## SERVICE DIRECTIVE BULLETIN

SERVICE NOTE NO. 0034

Subject: Copilot's Tail Rotor Pedal Clearance with the Defroster Installation Mount Bolt

Model: F-28A Only

FIGURE 1

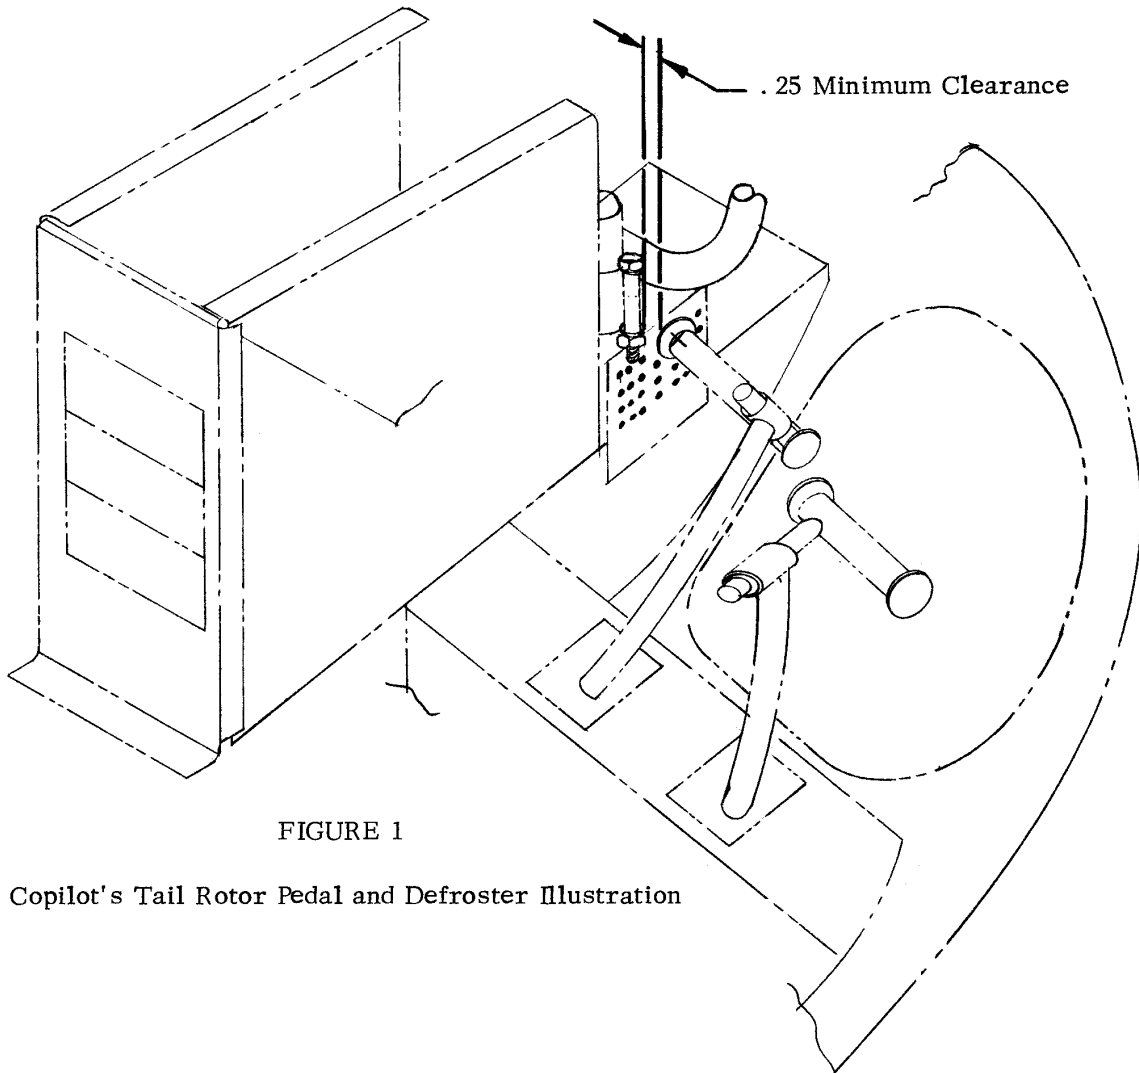
One occurrence has been reported of the copilot's left tail rotor pedal interference with the defroster mount bolt.

1. Push the tail rotor pedals to the full left position.
2. Push the inboard copilot's pedal laterally toward the center of the helicopter to take up system tolerances.
3. Maintaining hand pressure to the left, move the inboard or left tail rotor pedal aft to the stop. The minimum clearance is illustrated on page two, Figure No. 1, of this service note.
4. Items 1, 2, and 3 are to be repeated with the tail rotor pedal in all six of the foot adjustment positions.

If any interferences are found, contact Enstrom Customer Service Department for replacement foot supports (2 required).
